# Lime Down

Solar Park

## Outline Construction Traffic Management Plan (Tracked)

Revision **23**

APFP Regulation: 5(2)(a)  
Application Doc no.: APP / 7.22  
Drawing no.: Figure 5.2

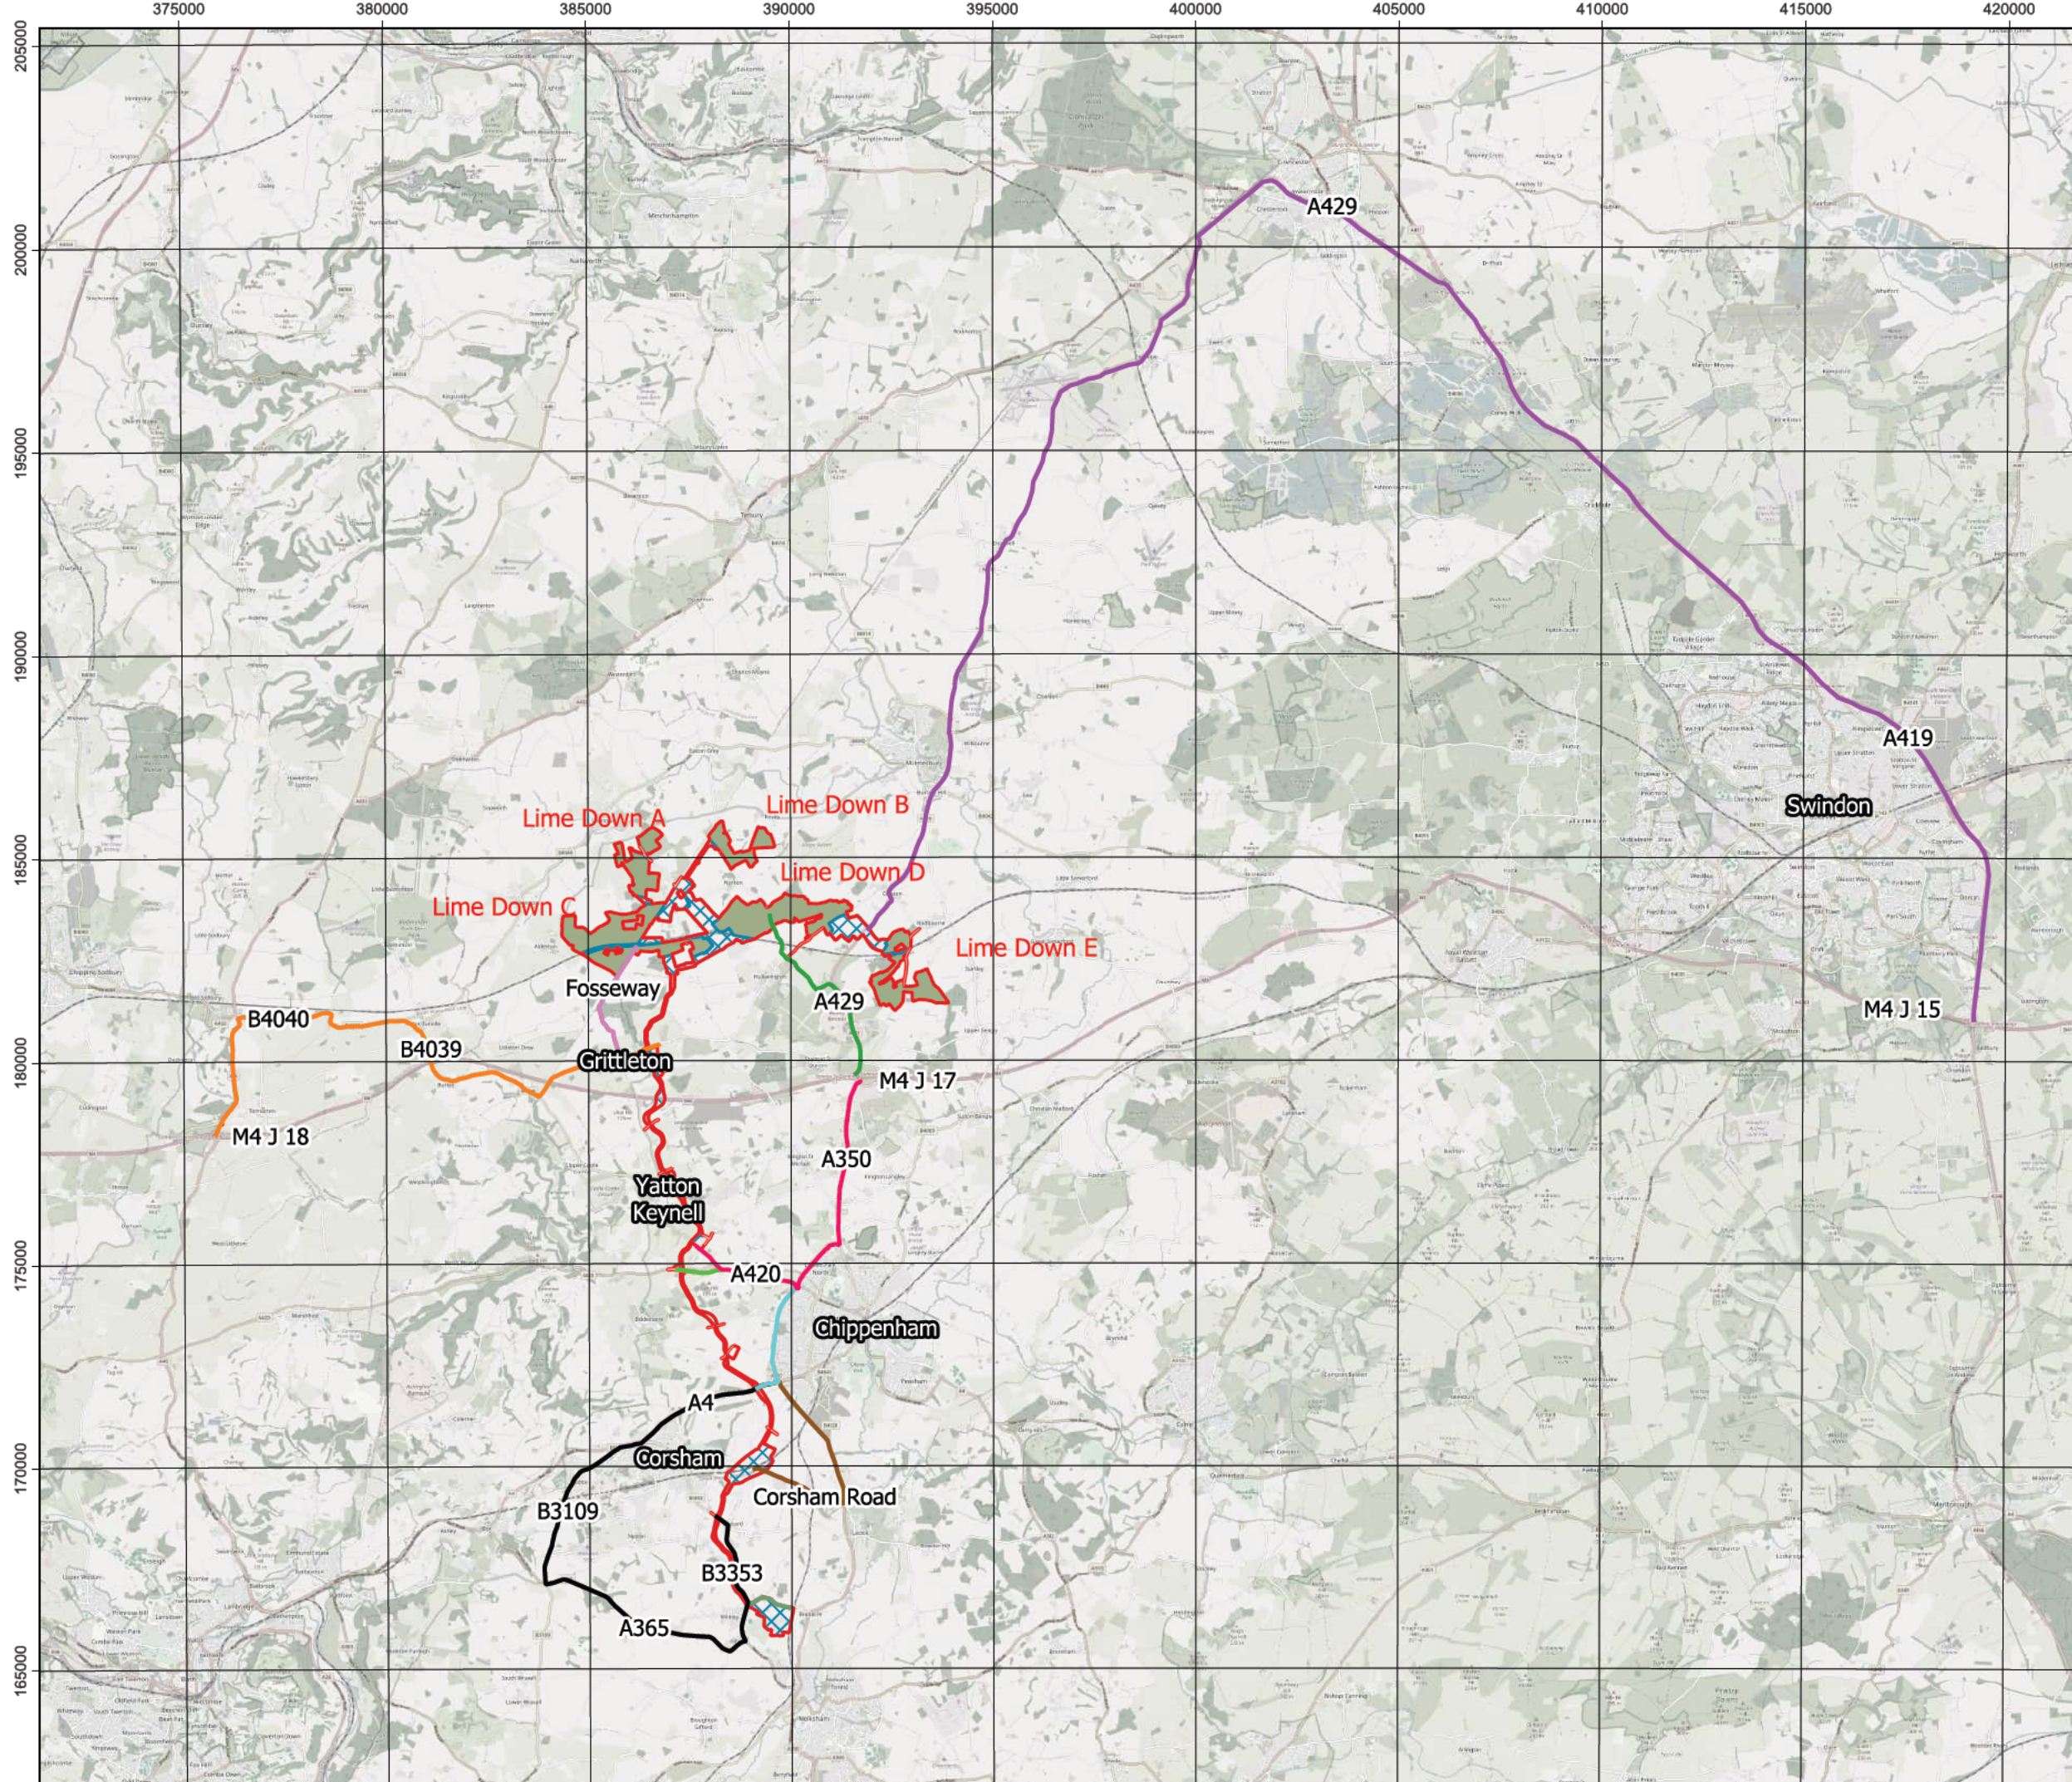
Figure 5.2	Figure added to show AIL routes to Cable Route Corridor	Included for Deadline 1 of Examination following hearings
	Table 8, Appendix D	Updated to provide breakdown of abnormal load movements	Updated for Deadline 1 of Examination in response to
